## RESIDENTIAL DEVELOPMENT

Lands at Clonburris, County Dublin

Kelland Homes

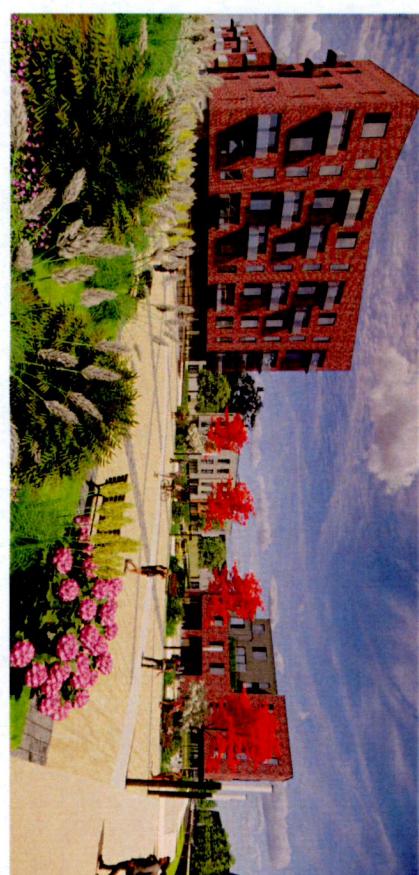
Materials and finishes should be revised so that render is reduced or fully omitted from the development. The apartment balconies should have metal railings. Variation in materials and colours should be provided along the houses.

Apartment balconies can be metal railings. However, it is considered that the clear glazed balcony guarding proposed would provide a higher quality finish and aesthetic to the apartment buildings. The applicant wishes to retain this specification and otherwise request the planning authority to justify with condition why metal balustrades should be used in place of glazed guarding.

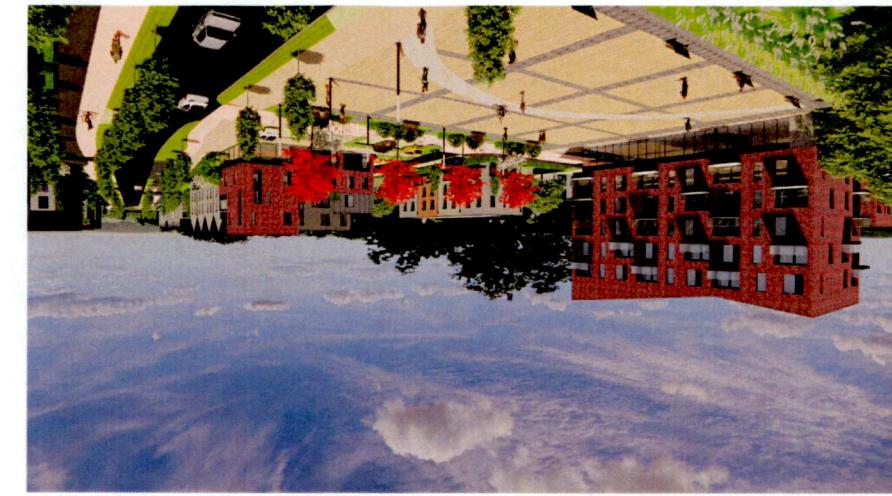
14(G) The level of commercial/retail floorspace should be increased or at least further facilitated in the future through the provision of flexible designs, including the development onto the proposed plaza.

Urban design considerations such as pedestrian and cyclist permeability and connections to and from the plaza have been applied to the masterplan layout. It is considered that proposed plaza will thus provide a local urban node / focal point in both the context of the proposed development and in the context of the adjoining site, should the entire CUC S4 lands be developed in time.

A masterplan design layout for the entire CUC-4A has been provided to inform the context of the proposed plaza. This layout ties the proposed application proposal to the adjacent site to the west in a coherent manner that directly reflects the design intent of the Planning Scheme.
